Revisions	Date
⚠ADDENDUM 2	04/19/21

Drawing Title: BASEMENT/CRAWL SPACE REFERENCE PLAN
Approved Project Director:
Project Title: ST CLOUD ADH AND EC SUPPORT
Location: ST CLOUD VA HEALTH CARE SYSTEM, 4801 VETERANS DRIVE, ST. CLOUD MN 56303
Date: 12–27–2019
Checked: AB
Drawn: AB
Project Number: 656-343
Building Number: ---
Drawing Number: ⚠ AE105

F1 BASEMENT/CRAWL SPACE REFERENCE PLAN
1/8" = 1'-0"

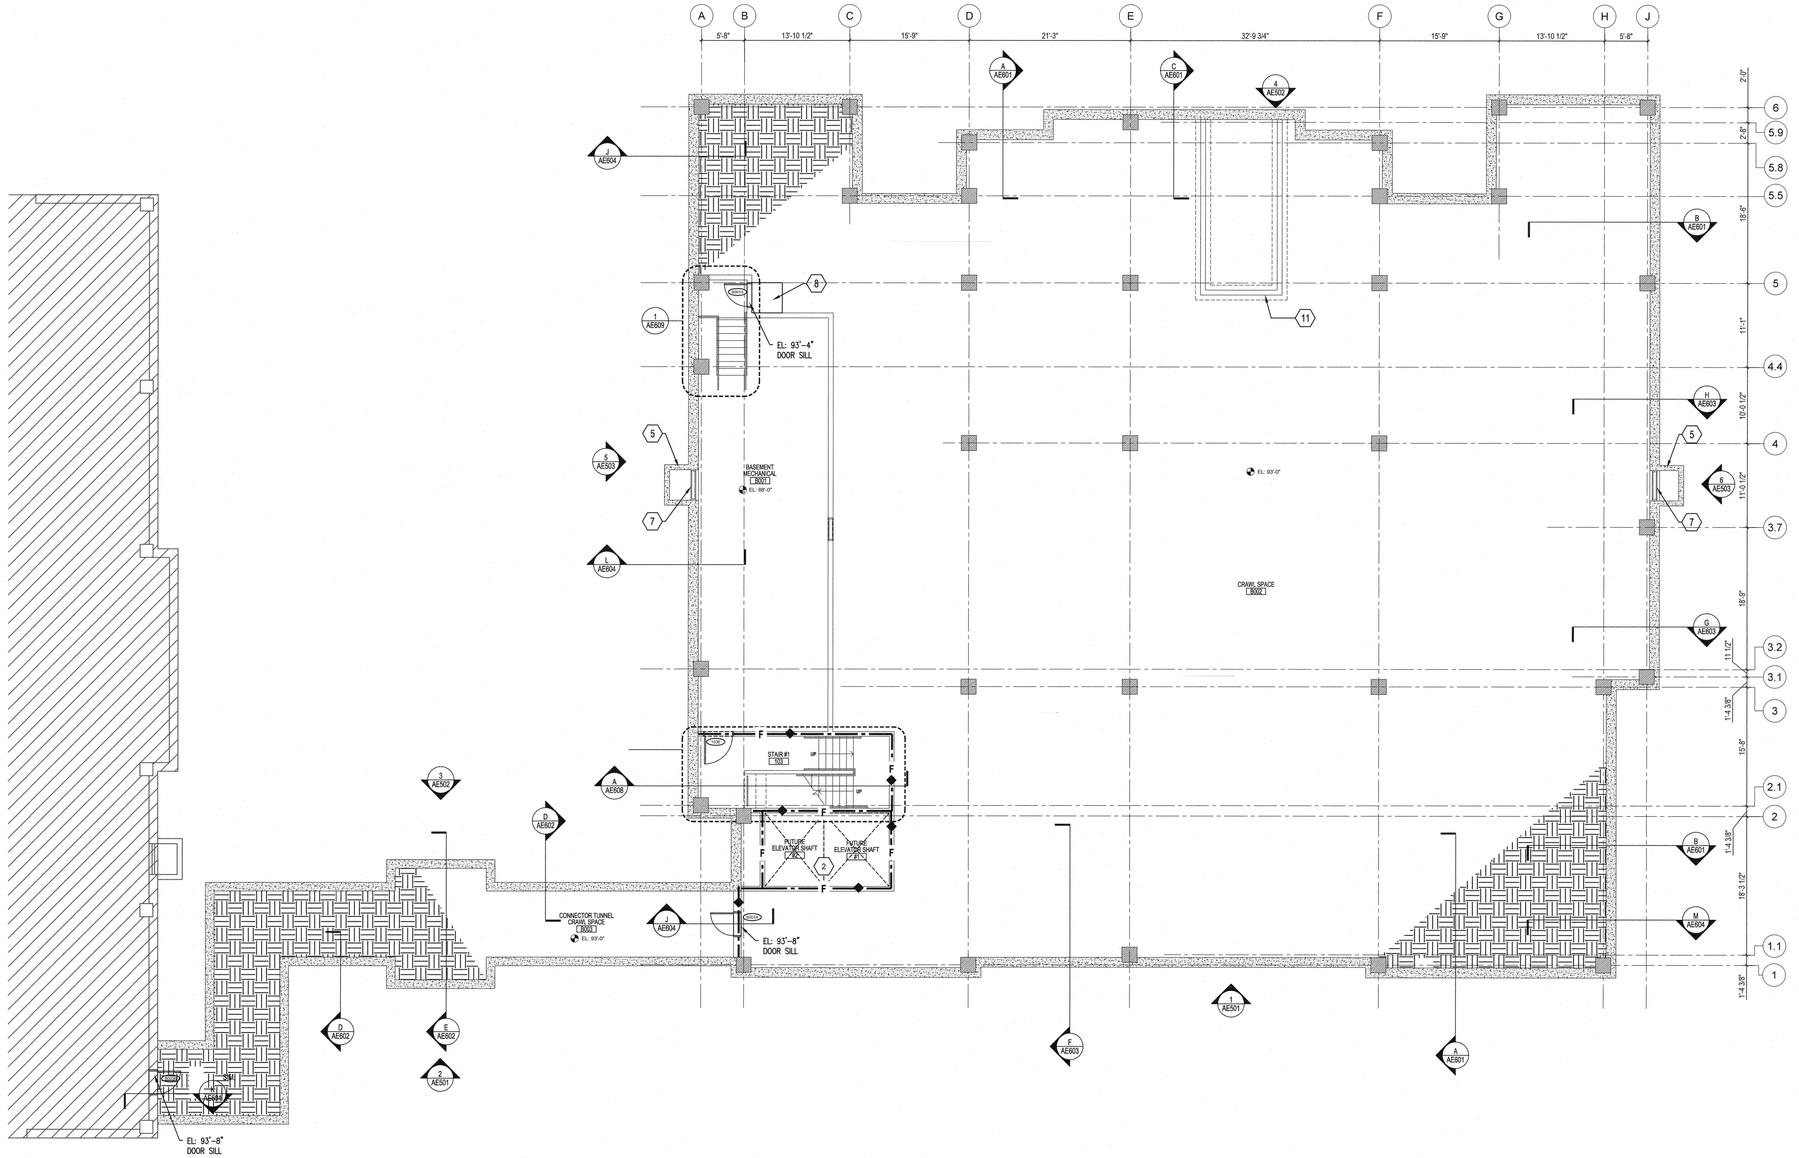
⚠2 BOLLARD BASIS OF DESIGN MFR: WIKK INDUSTRIES BOLLARD SQ2
   PART #: B–6SQ–RT–DB–SM–SG
   MATERIAL: ALUMINUM
   FINISH: DARK BRONZE ANODIZED (710)
4. 4" HIGH CONCRETE HOUSEKEEPING PAD, REFER TO STRUCTURAL DRAWINGS FOR ADDITIONAL INFORMATION.
5. CONCRETE AREA WELL, REFER TO STRUCTURAL DRAWINGS FOR ADDITIONAL INFORMATION.
6. AREA WELL METAL GRATING, REFER TO WALL SECTIONS AND SPECIFICATIONS FOR ADDITIONAL INFORMATION.
7. AREA WELL METAL LOUVER, REFER TO OPENING SCHEDULE AND SPECIFICATIONS FOR ADDITIONAL INFORMATION.
8. 4' X 4' X 6" REINFORCED CONCRETE STOOP WITH #4 REBAR AT 12" O.C. IN BOTH DIRECTION.
9. REINFORCED CONCRETE MECHANICAL HOUSEKEEPING PAD, REFER TO STRUCTURAL FOR ADDITIONAL INFORMATION.
10. TWO–TIER METAL LOCKERS 15"W X 18"D X 36"H (PER LOCKER)
11. CONCRETE WALL AND FOOTING FOR SUPPORT OF FUTURE CMU STAIRWELL WALLS. REFER TO STRUCTRUAL DRAWINGS FOR ADDITIONAL INFORMATION.
